<p><b>ALTITUDE</b> RIDES AND ATTRACTIONS</p>	<b>Issuing Entity:</b>	<b>Bulletin #:</b> SB-SEZ-02-2026
	Altitude Rides and Attractions, LLC	<b>Release Date:</b> Feb 19, 2026
	2395 N. 400 W., Logan, UT. 84341, US	<b>Effective Date:</b> Operational Procedures and Training are to be revised immediately. Equipment modifications are to be accomplished within 120 days
	Phone #: 435-258-7901	<b>Supersedes:</b> Prior Operations Manual, Rider Restraint Instructions and Restraint Configurations
	<b>Email:</b> <a href="mailto:parts@altitudeattractions.com">parts@altitudeattractions.com</a>	<b>Completion Date:</b> Operational Procedures and Training are to be revised immediately. Equipment modifications are to be accomplished within 120 days
<b>Website:</b> <a href="http://www.altitudeattractions.com">www.altitudeattractions.com</a>

## SERVICE BULLETIN

<b>Ride Manufacturer(s):</b> Soaring Eagle, Inc. & Altitude Rides and Attractions, LLC	<b>Affected Production Dates:</b> All Years
<b>Ride Name:</b> Soaring Eagle Zipline Ride	<b>Affected Serial Numbers:</b> All
<b>Model Numbers:</b> All Models

### Abstract of Issue:

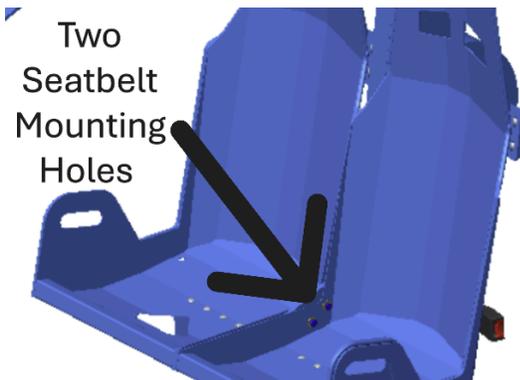
1. Visually inspect the passenger cart and determine whether it is equipped with **one or two seatbelt mounting holes**, as illustrated below.

- a. Contact Altitude Rides and Attractions, LLC to order the proper updated shoulder restraint kit. Be prepared to specify whether the passenger cart is equipped with **one or two seatbelt mounting holes**.
